Progress Report
Fourth Quarter 2007 through First Quarter 2008
Midwest Roadside Safety Facility
Mid-States Regional Pooled Fund Program
March 17, 2008

Pooled Fund Consulting Summary

Midwest Roadside Safety Facility
November 2007– January 2008

Figure 1. End Terminal Slope

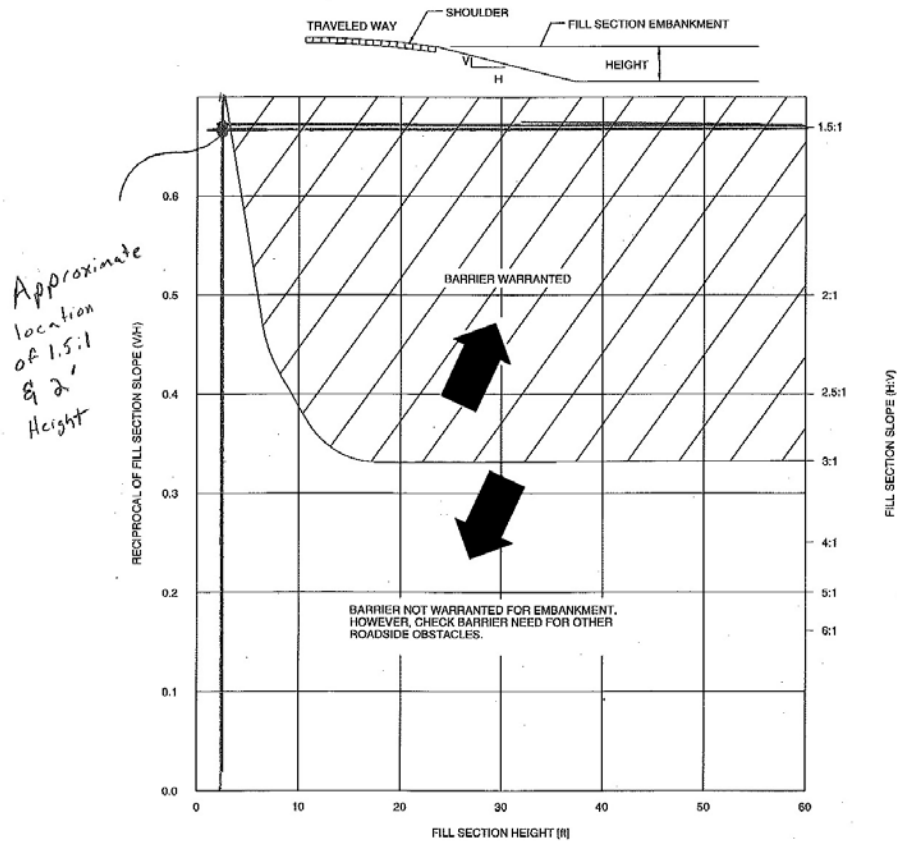
Earlier this week I had the opportunity to drive through various construction sites that were retrofitting energy absorbing terminals (See attached pictures). One question I had was about the slope just off of the gravel widening near the terminal. In this case the slope is approximately 1.5:1 and the terminal platform is approximately 2' higher than the grass slope. The grass slope is typically 4:1 or flatter. Figure 5.1b, of the Roadside Design Guide would indicate that this is acceptable (see page 2).

Given the instability of a vehicle during impact with the terminal, should this slope be permitted at the terminal?

The attached figure contains current FHWA guidelines for grading around terminals. The green area must be 3:1 or flatter. Our research would suggest that the orange region could be as steep as 3:1, even though FHWA gives a more conservative recommendation. We do not believe that 1.5:1 is acceptable under any circumstance.

Figure 6. Unreinforced PCB

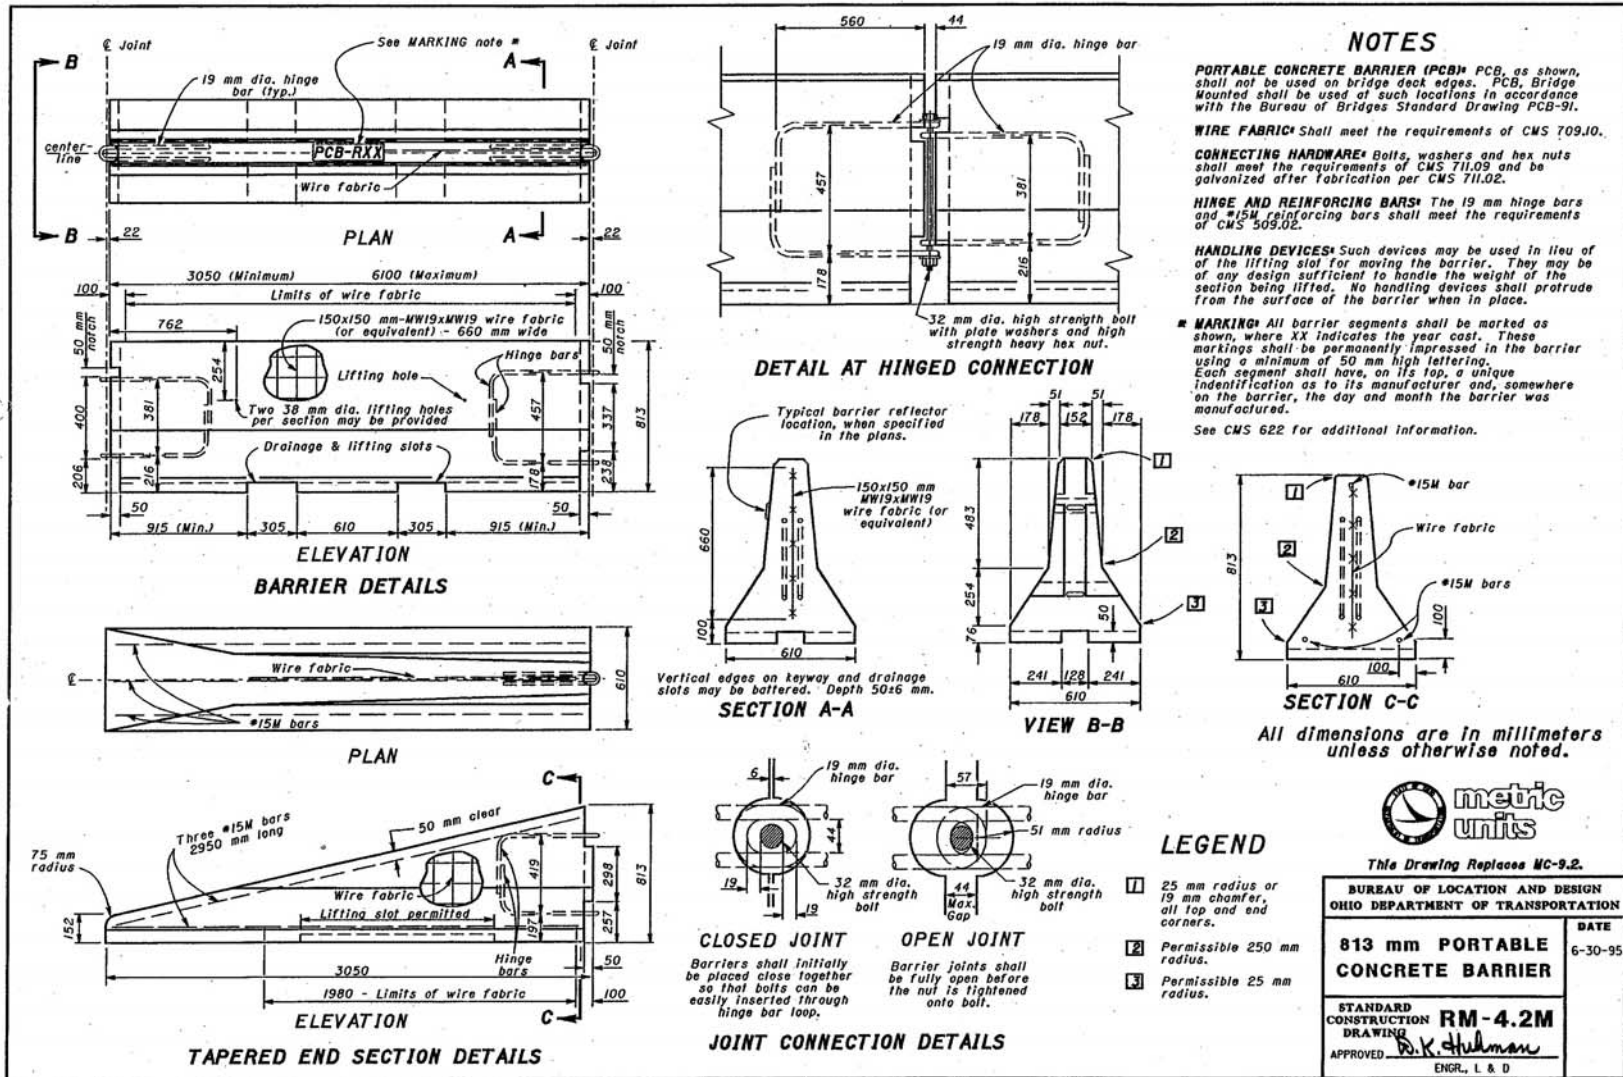
I know there is no FHWA mandate to remove the barrier, and it is ODOT's own arbitrary deadline, but do you believe unreinforced barrier would meet TL-2 criteria?

Our 350 crash tested barrier has FHWA Acceptance letter B-93 (design is attached as rm42.pdf) and differs from the previous barrier design (attached as unreinforced 32 inch pcb.pdf) in only the internal rebar cage in lieu of the previous design's wire mesh. The pin and loop connection remained unchanged.

I would be of the opinion that if the rebar cage reinforced barrier meets 350 TL-3, then the same design with the wire mesh would be crashworthy to TL-2. What do you think? Your answer will influence our decision to on whether or not to keep this particular barrier run in place for another year.

We have looked at the unreinforced barrier section that you sent. It appears that that design does have some reinforcement in the form of a wire mesh in the center of the barrier. The connection design of the barrier seems adequate. Because the design does have some minimal reinforcement, adequate connections, and the fact that the anticipated loads for a TL-2 urban installation will be much lower than the TL-3 impact loads, we believe that this barrier, as shown on the detail you submitted, should be adequate for use in TL-2 urban installations.

One addition note on the detail is the tapered end section details. The TL-2 tested tapered end-section has been tested and required a 20' length. Thus, it appears the end section on your detail does not have sufficient length. We would recommend that you use an extended tapered end section if possible.

Figure 7. Traversable Culvert Grate

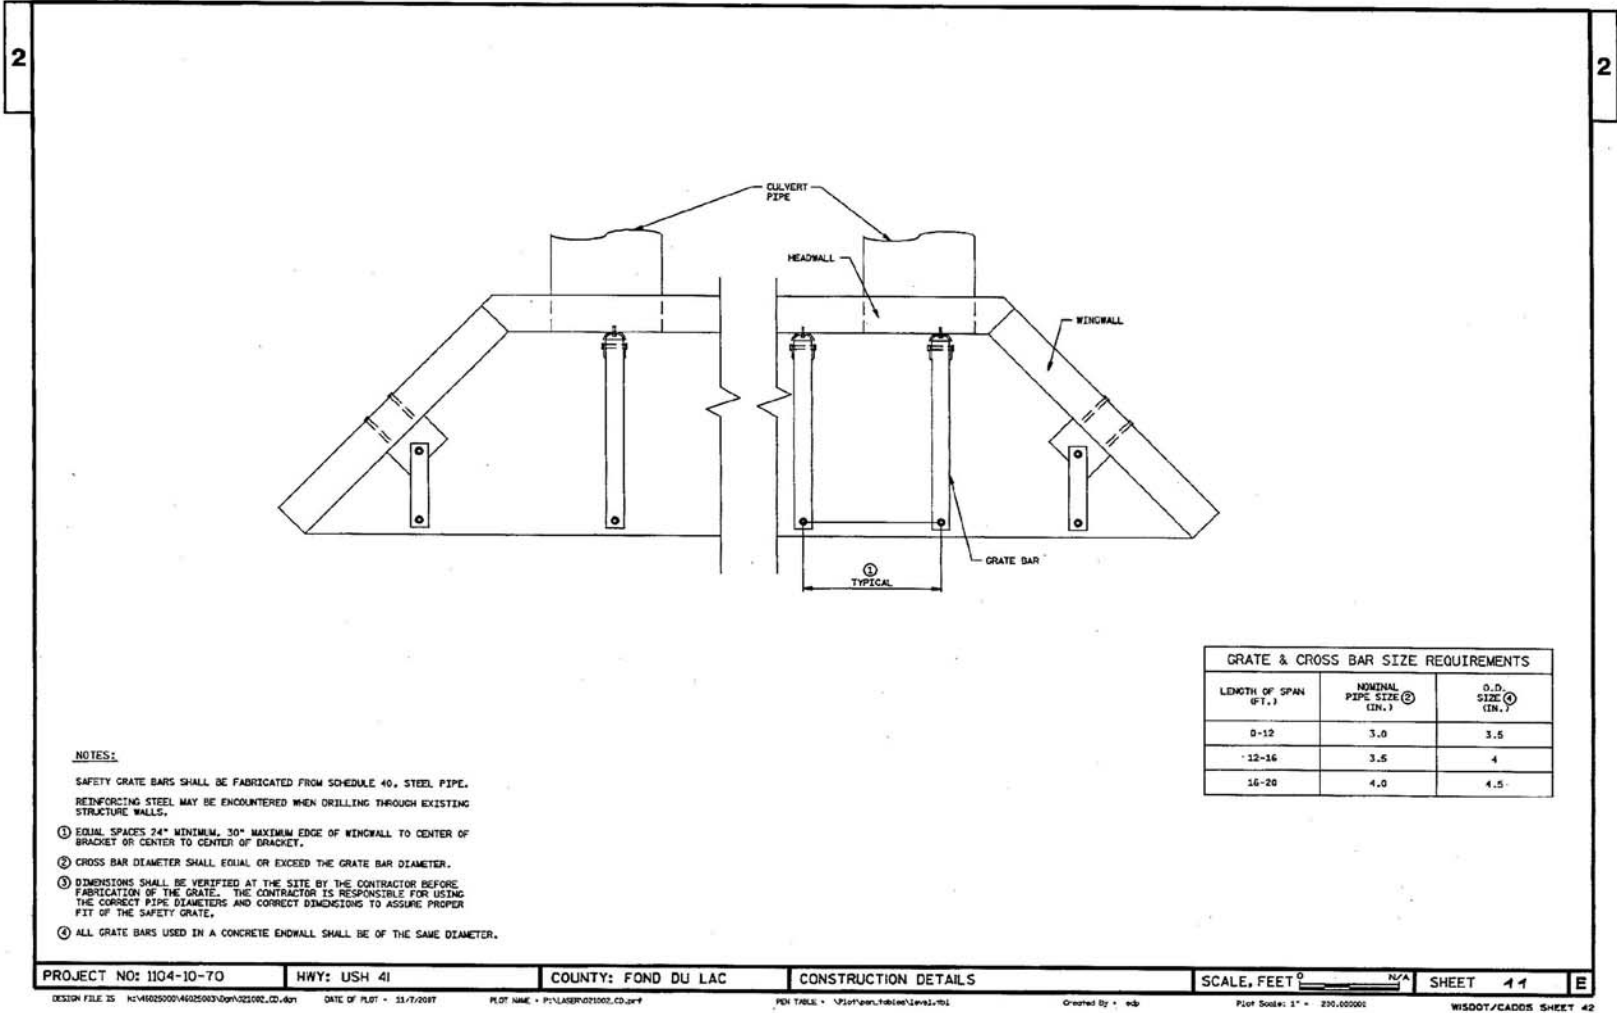
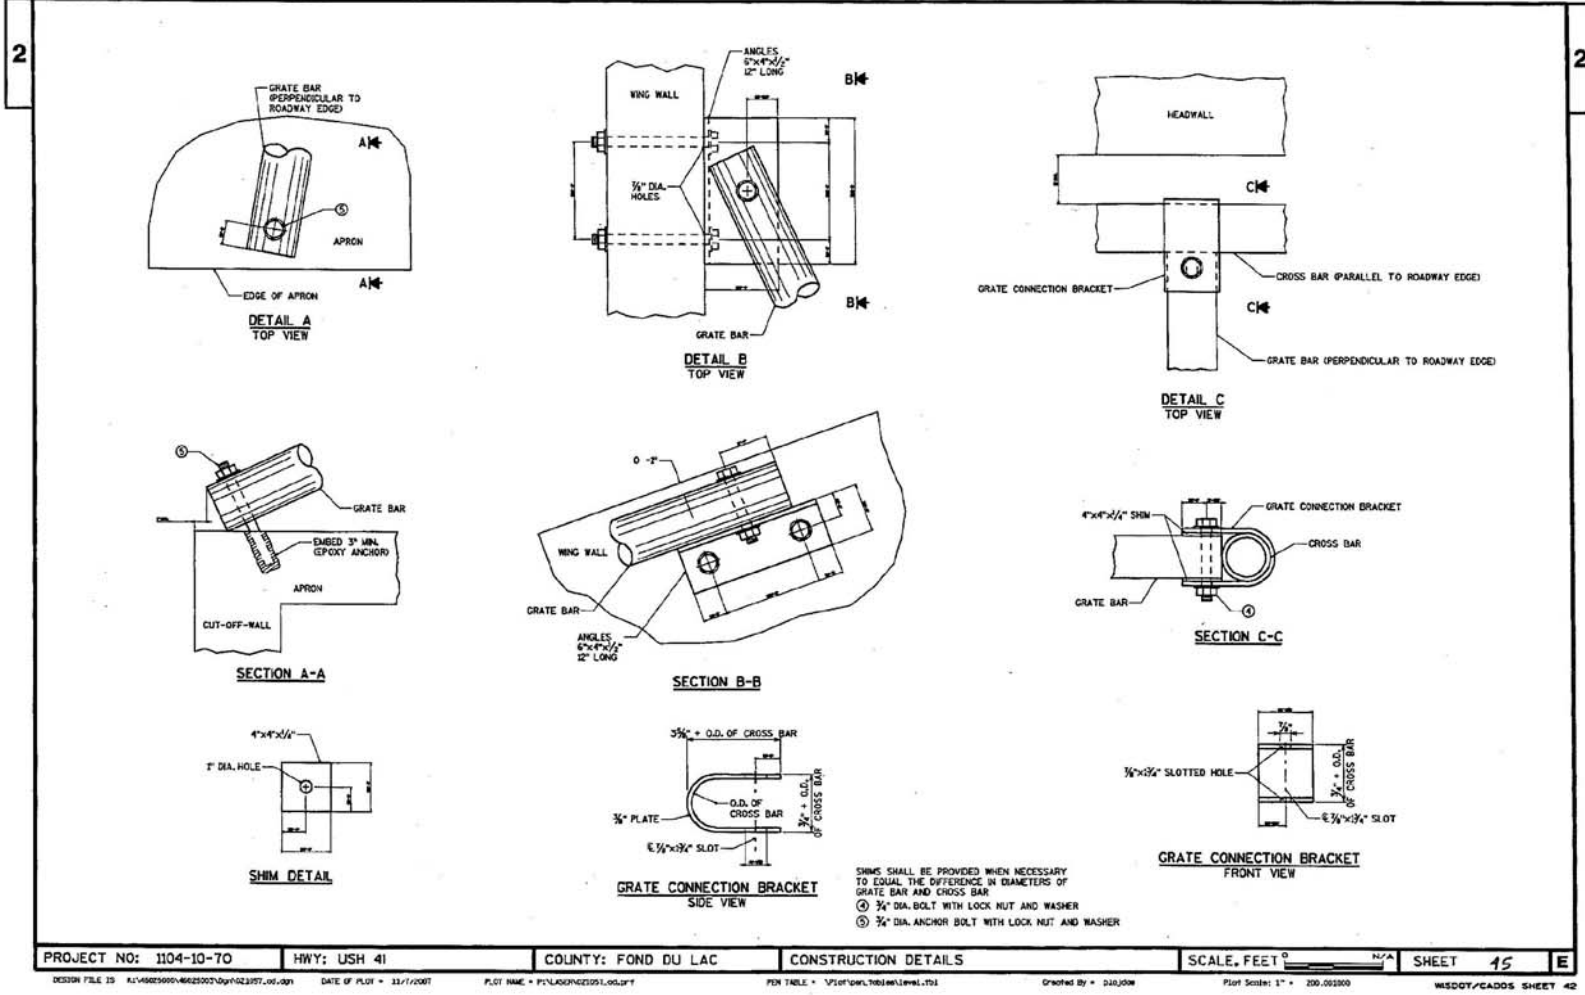
As I looked at the plan, I found out that the designer has developed a special detail to install steel bars to make a box culvert traversable (see attached details). I believe that the safety pipe runner spacing is correct. The inside diameter of the safety pipe runners are slightly over sized.

1. Does the Schedule 40 steel pipe have adequate structural strength to allow a vehicle to traverse the culvert?
2. Are the structural connections of the safety pipe runners adequate to allow a vehicle to traverse a culvert?
3. Does this detail have enough detail to be built?
4. Does MwSRF believe that this design is NCHRP 350 compliant?

1. The Schedule 40 pipe listed on your plans is sufficient for allowing the vehicle to transverse the culvert. The table in your plans is developed from testing done at TTI in 1980 and was later adopted as an AASHTO guideline. Furthermore, we conducted a test of the culvert pipes with the largest spacing and size in the table on a 3:1 slope with the 2000P vehicle and the 820C vehicle and found that the specified pipes and spacing were adequate.

2. I cannot fully evaluate the structural connections for the pipes from your plans. The bolt grades are not listed and no details of the culvert wall reinforcement are listed. I don't fully understand the detail for section C-C. This appears to be a detail for additional crossbars on culverts with over 20' spans. The overall details have no guidance on the location and so it is hard to evaluate. Cross bars should not be necessary on culverts with spans of 20' or less. Do you expect to install culvert grates on culverts larger than this?

3. I would add the bolt grades and the details for the cross bar installation location if necessary. Your design appears to be identical to the Iowa DOT culvert detail. There detail is more complete in terms of specifying the cross bar details and such. You may want to look at their details for further guidance.

4. If the connections for the pipes to the headwall are structurally sufficient, this design should be NCHRP 350 compliant.

Figure 1. Illinois PCB to Rigid Barrier Transition Schematic

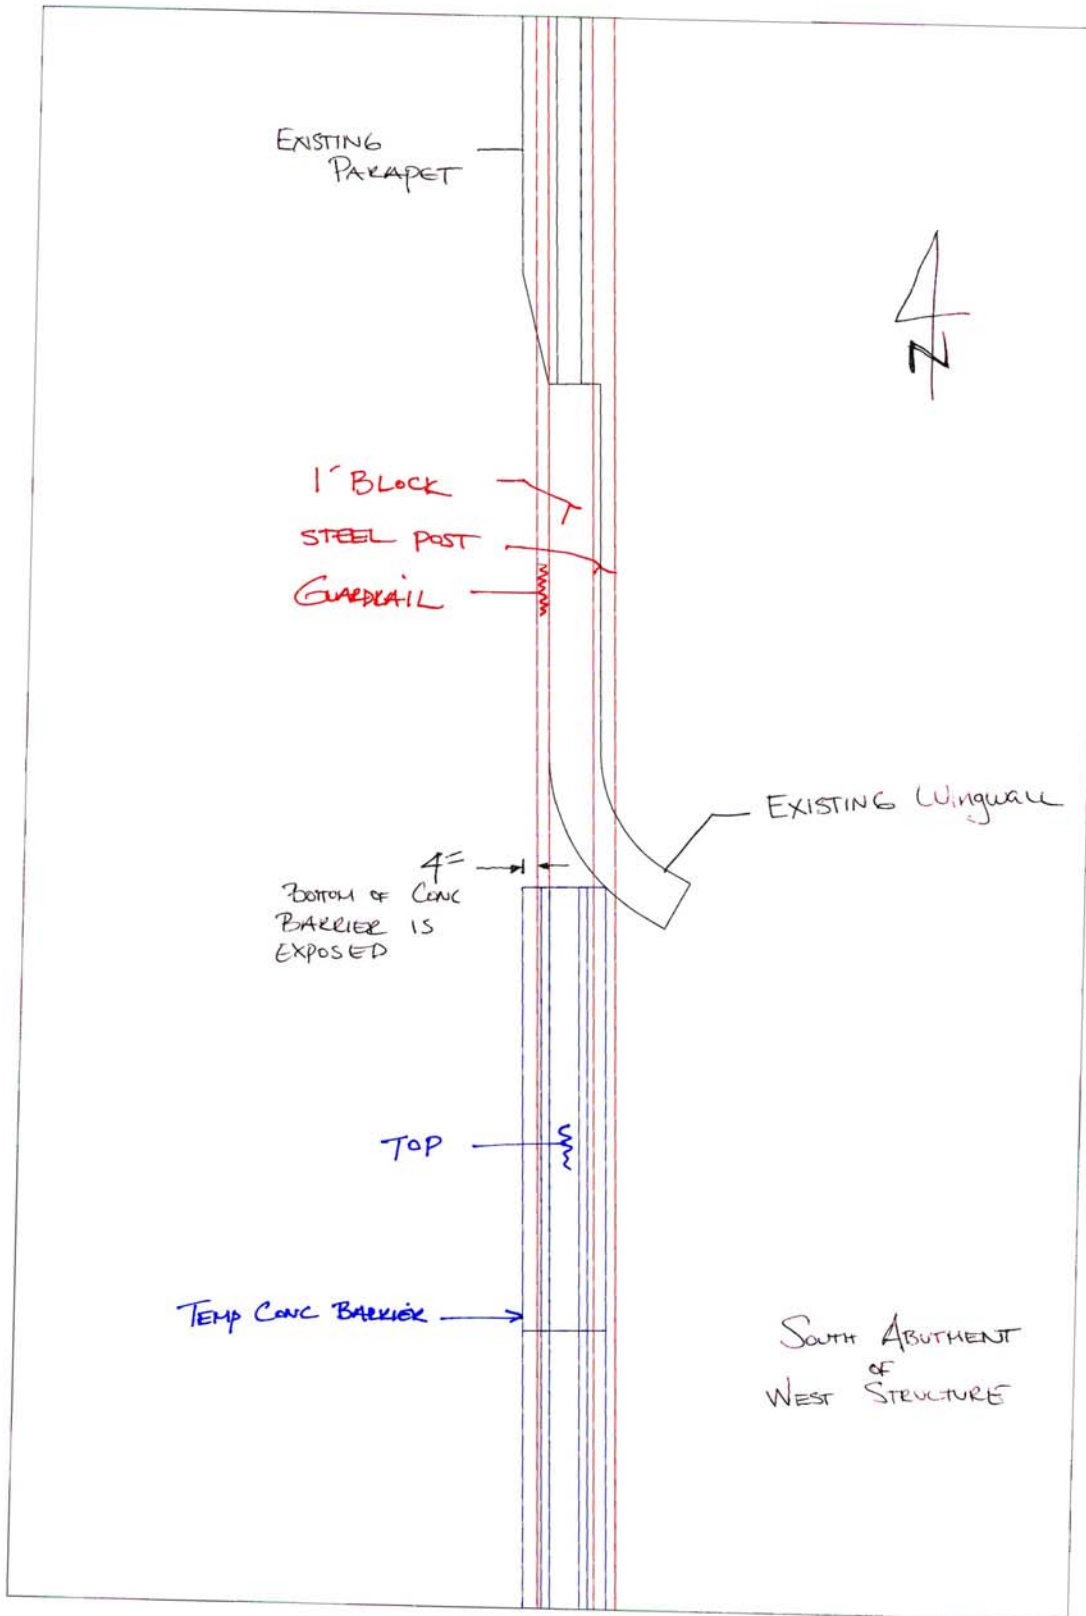
However, I have an immediate question from one of our districts regarding a transition to an existing bridge parapet. In this case the parapet end is curved away from traffic, making connection of the TCB problematic. There is no ready way to adapt to a pinned connection, and also spanning the back side of the joint with the thrie beam is not possible without removing part of the parapet end.

There seem to be a couple possibilities – remove and recast the end of the parapet to work with the TCB, or perhaps fabricate a triangular steel shape to bolt to the face of the parapet and provide a connection point and also fill over the curved portion. This latter idea still leaves the question of how to span the back of the joint.
